Our ref: 003978-LTR-4

**Conditional Approval and Final Comments
Regarding the Conceptual Plan Letter (the Plan) for Modifications to the
Wausau Drinking Water Treatment Facility (DWTF)
Wausau Water Supply Superfund Site
Wausau, Wisconsin**

**City of Wausau New Drinking Water Treatment Facility
and Changes to the Treatment of City Well CW-3-Revised
Wausau Water Supply NPL Site
Wausau, Wisconsin**

FIGURE 2

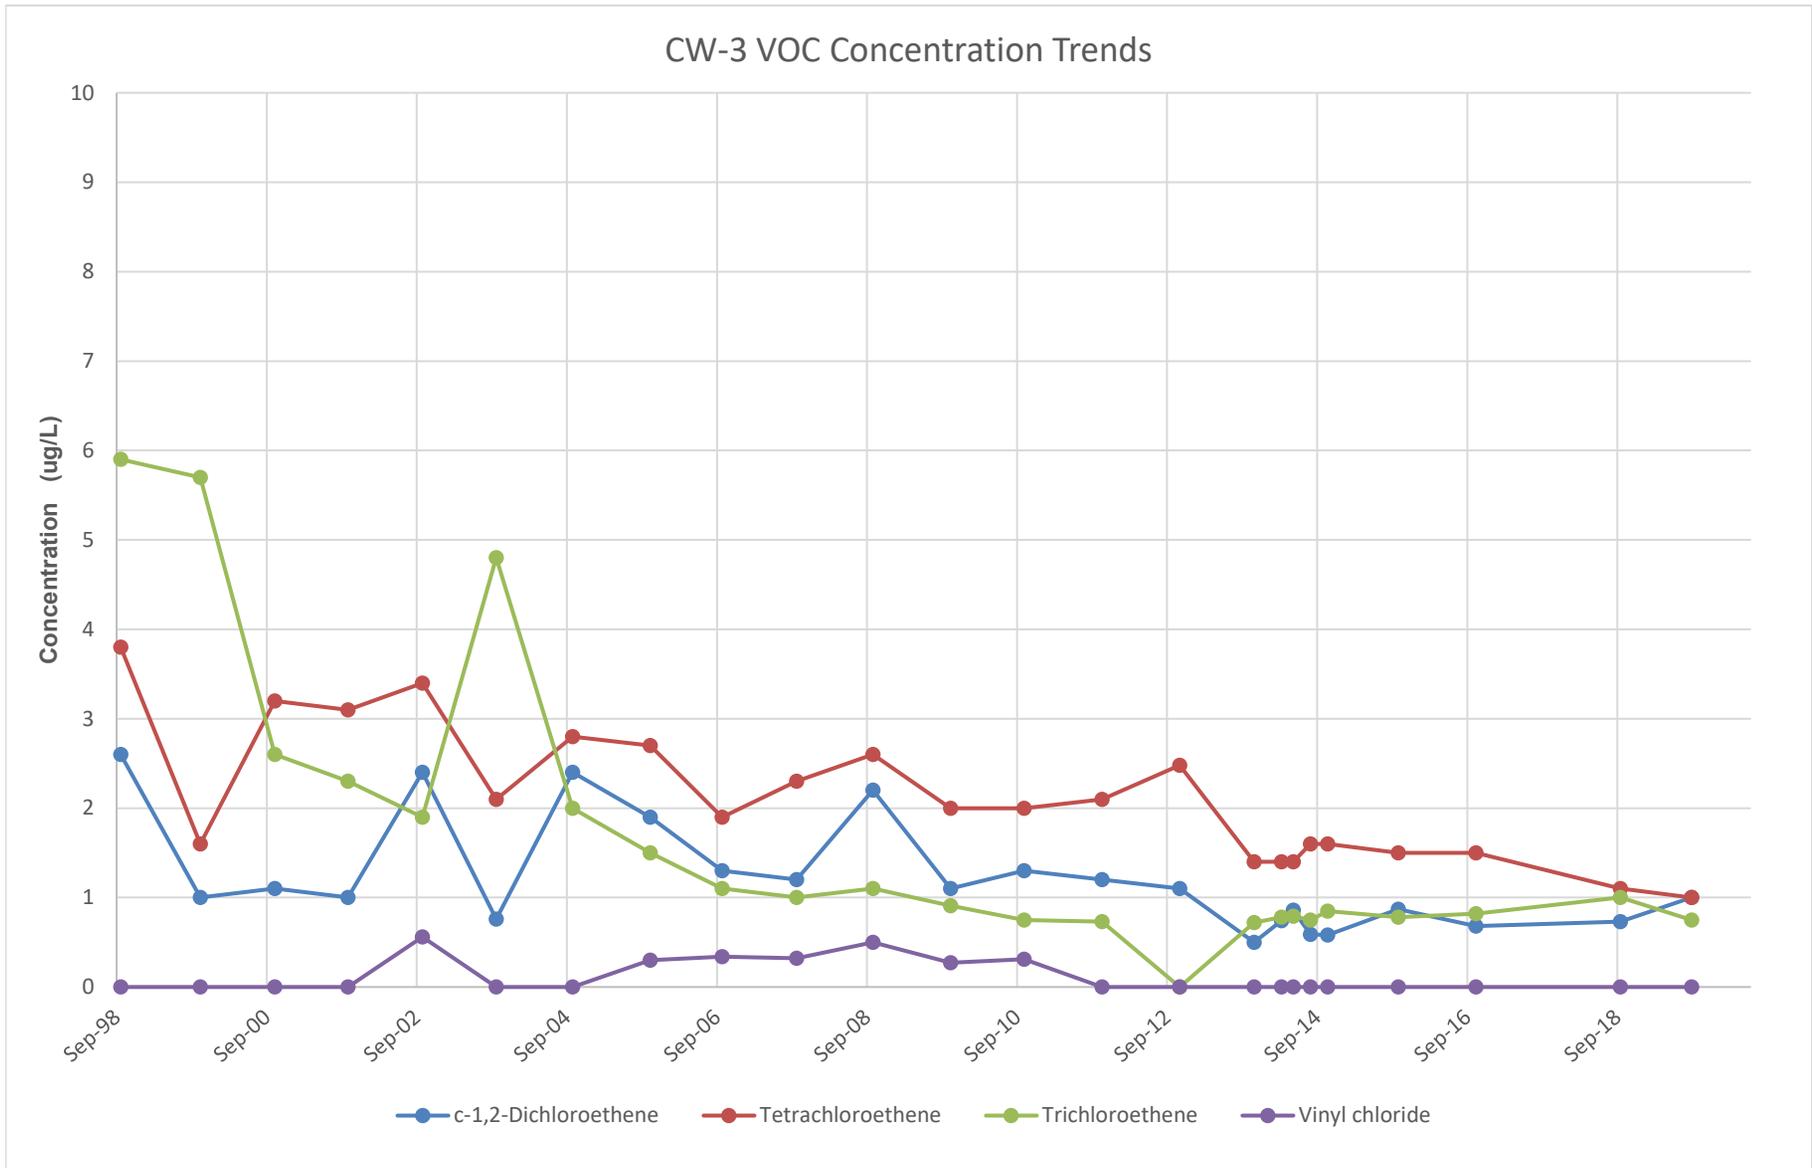
Explain in more detail the trend of contamination found in the groundwater on the east side of the Wisconsin River and why air strippers are no longer needed as part of the treatment system from CW-3 including an analysis of the levels of contamination from CW-3 since the inception of the remedy for the Site. Explain what will happen to the existing air strippers. Explain further what will happen to the pumped water from CW-3.

VOC concentrations on the east side of the Wisconsin River have generally been decreasing or stable over the last several decades. Instances of increased VOC concentrations have occurred at many of the monitoring well locations in recent years, however CW-3 seems to be far enough away from the source zone that even moderate changes in VOC concentrations near the source zone do not eventually show up in CW-3 sampling data. CW-3 influent samples have not exceeded any enforcement standards for any constituent of concern since 1998 and total VOC concentrations have been steadily decreasing since that time. Figure 2 in the Plan illustrates this downward trend. Prior to 1998, total VOC concentrations in the CW-3 influent were much higher than recent concentrations. Total VOCs at CW-3 during the first sampling event in 1994 were approximately 35 µg/L, compared to below 4 µg/L in the most recent ten sampling events.

CW-3 influent sampling data has consistently shown levels of VOC constituents of concern to be below drinking water enforcement standards for over twenty years. It is anticipated that the enforcement standards for discharge to the Wisconsin River will likely be less conservative than the current drinking water standards. Since the City plans to discontinue use of CW-3 as a drinking water source well, there is no need to continue operating they air strippers.

E. WAUSAU AVENUE
N. 2ND ST RR TRACKS TO WISCONSIN RIVER
WELL NO.3 STORMWATER CONNECTION PLAN

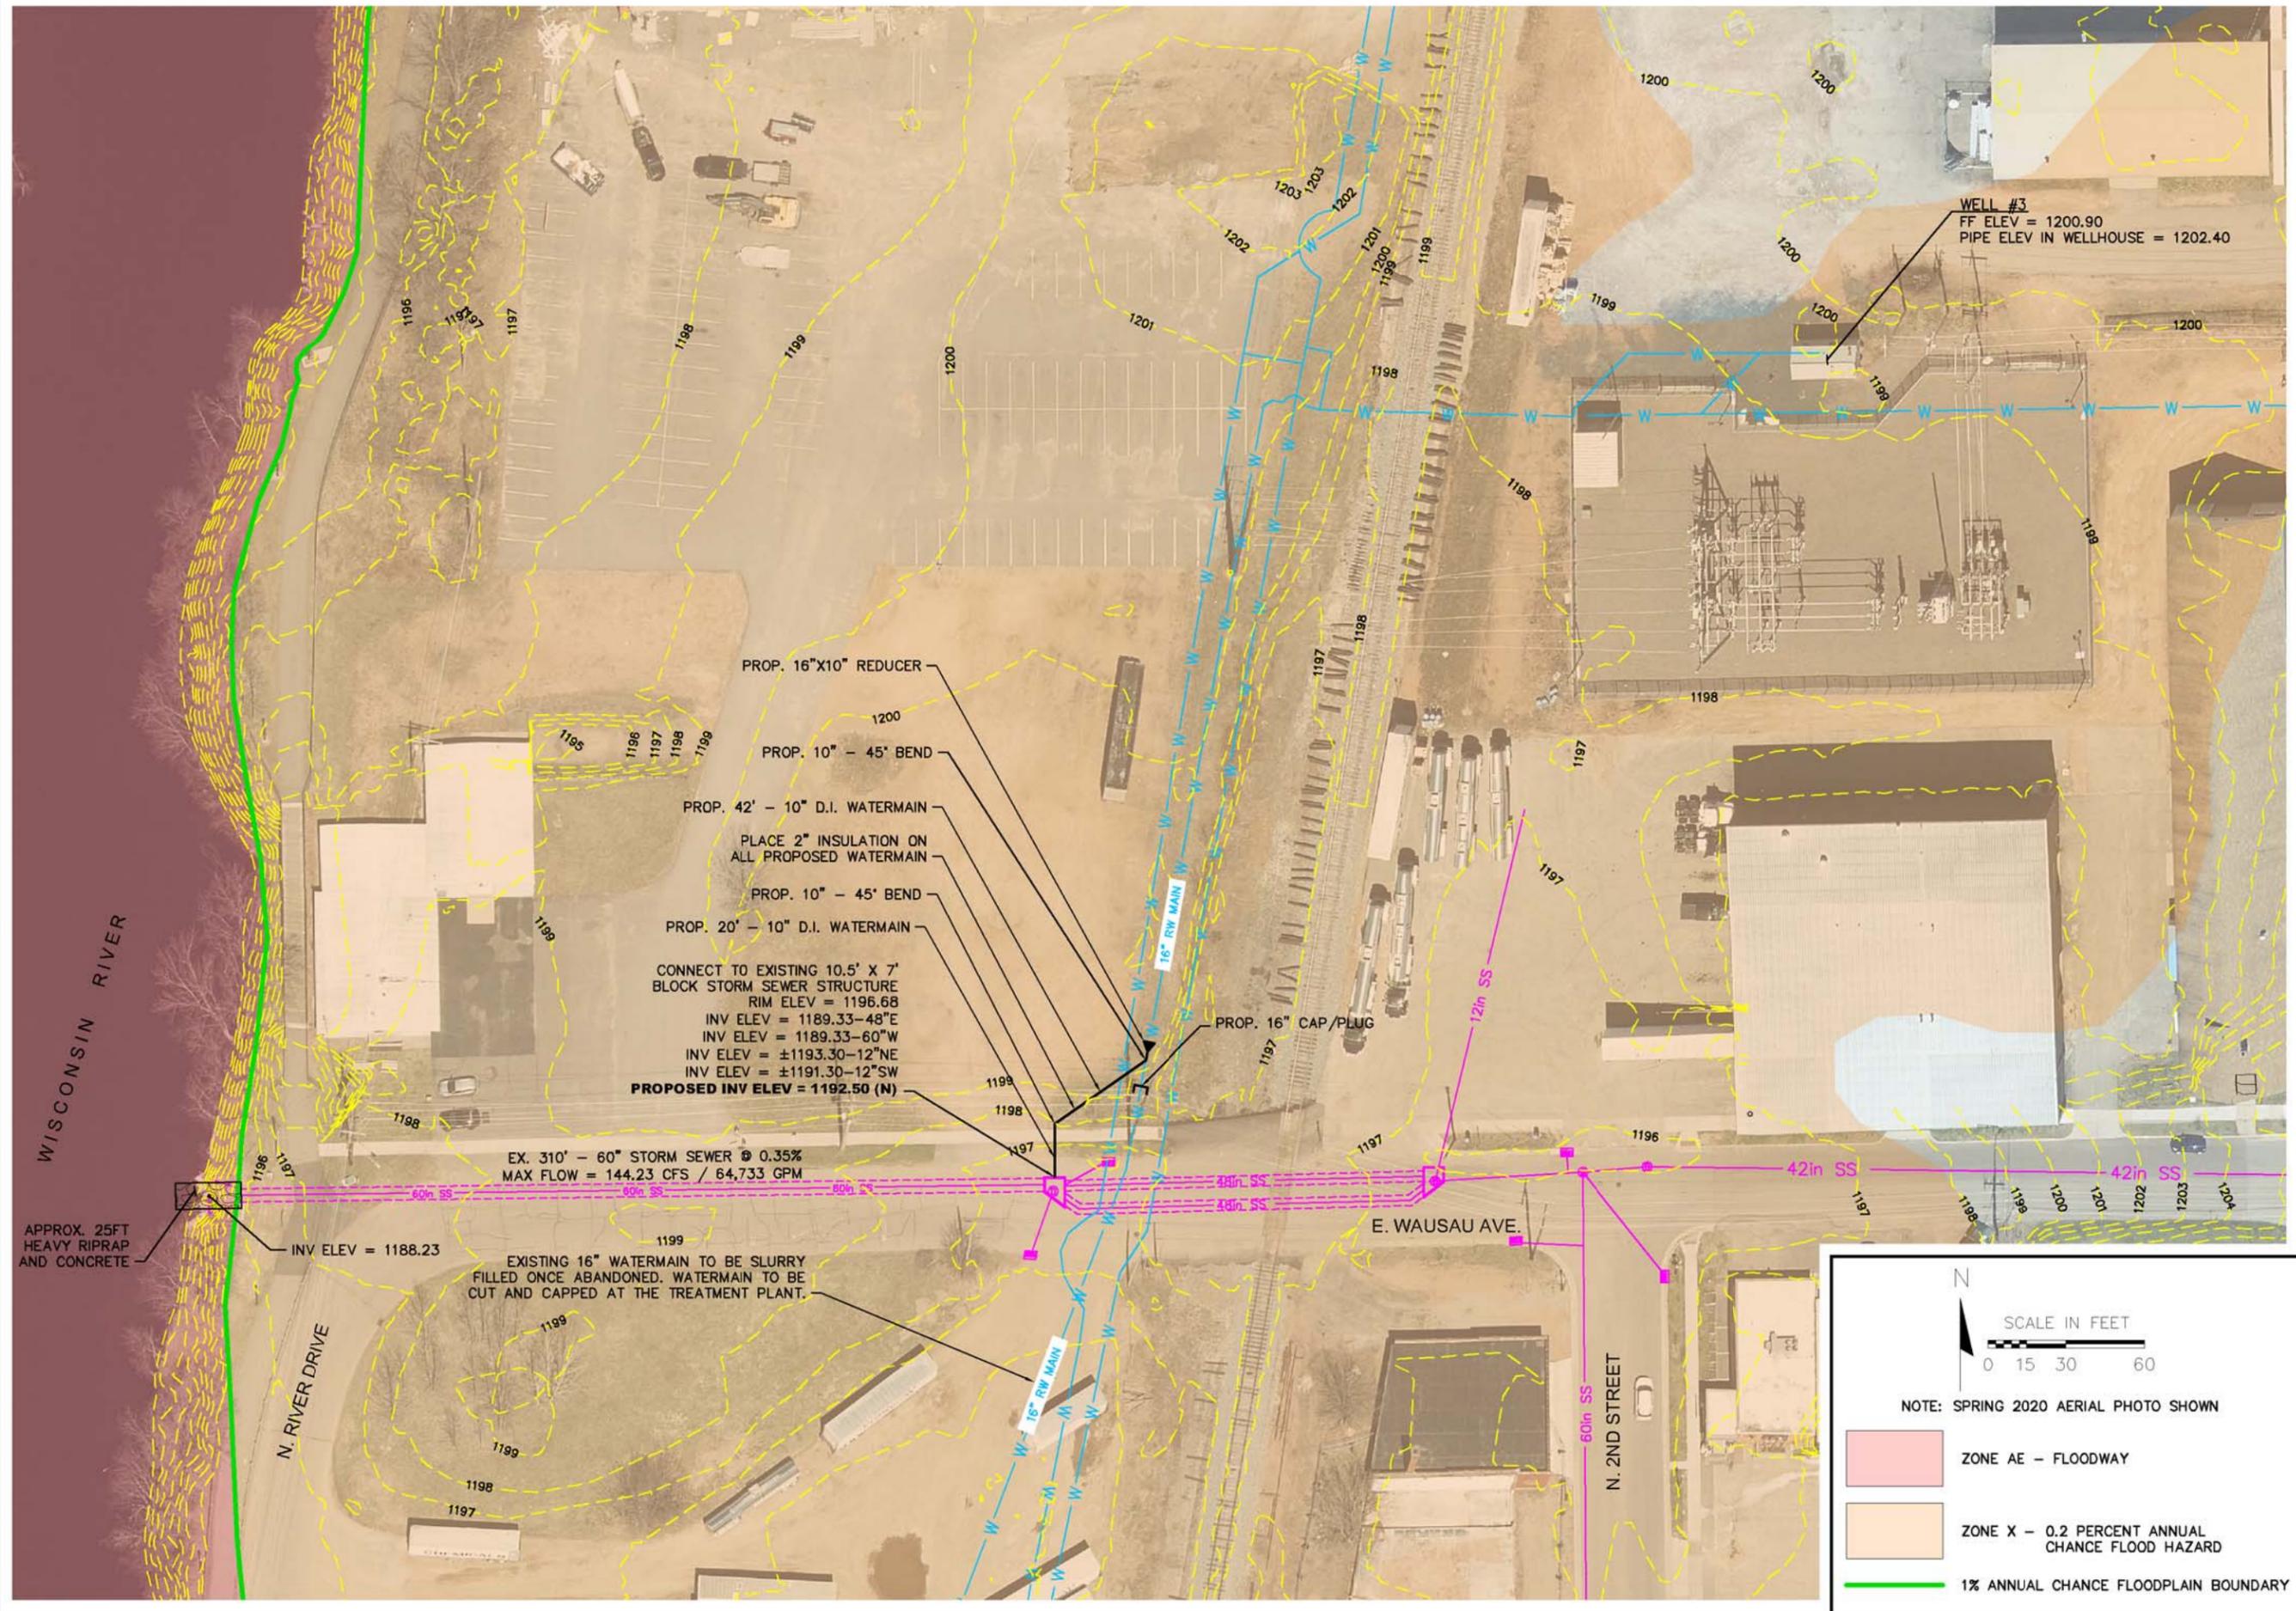
The Plan should provide additional details as to whether the sewer pipes and reducers have the capacity to handle the volume of required effluent both in normal times and during storm and flood events.

The piping discharge system has been designed to be able to handle effluent volumes in both times of normal operation, as well as storm and flood events. The Plan has been updated to reflect the USEPA and WDNR's comment. Additionally, a figure has been added to superimpose the 100 and 500-year flood zones onto the CW-3 Plan area, for reference.
